## PRODUCT CHANGE NOTIFICATION

#PCN-IF-VBYY-15

<b>Business Unit</b>	<b>Product Line Code</b>	Type of Change	Action	Date of issue
IF	CK6	Improvement	Notify	7/2/2015
			Distributors	
			and Field

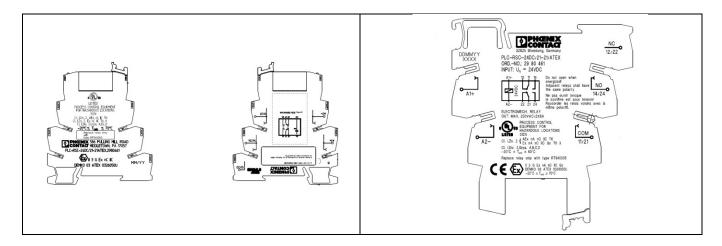
The ATEX relays are now global part numbers and being manufactured at the Phoenix Contact Bad Pyrmont facility, in Germany. The last digits of the part number descriptions have all been updated so that they have the same uniform ending, reading ATEX. The printing on the socket/base was two-sided, it is now combined and printing appears only on one side. See images below.
